NRL/MR/7441--94-7538

Digital Mapping, Charting, and Geodesy Analysis **Program Technical Review of Raster Product** Format (RPF) and Scanned Map (SMap)

# Digital Mapping, Charting, and Geodesy Analysis Program Technical Review of Raster Product Format (RPF) and Scanned Map (SMap)

Figure 1. Example diagram showing boundary rectangle, frame, and subframe referencing

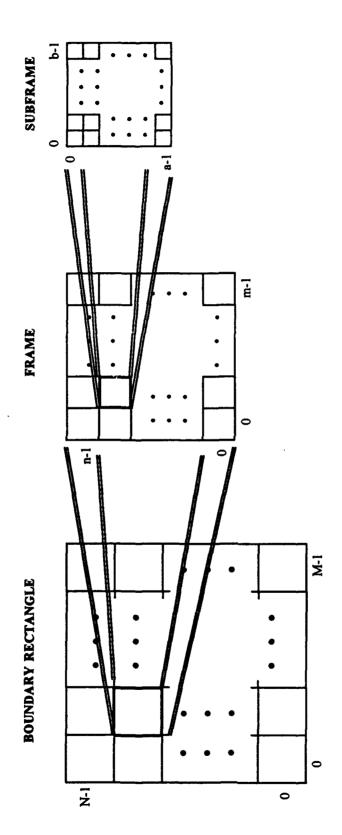
- 12. p. 20, l. 10 Different variables should be used to describe subframe size in sections 5.1.3.c.1 and 5.1.3.c.2 since N and M were used to describe frame size in 5.1.3.b.1 and 5.1.3.b.2. A figure (an example is given in Figure 1 of this review) showing the way in which frames and subframes are referenced within boundary rectangles is recommended.
- 13. p. 23, l. 20 The wording in this section, although technically correct, could be modified.
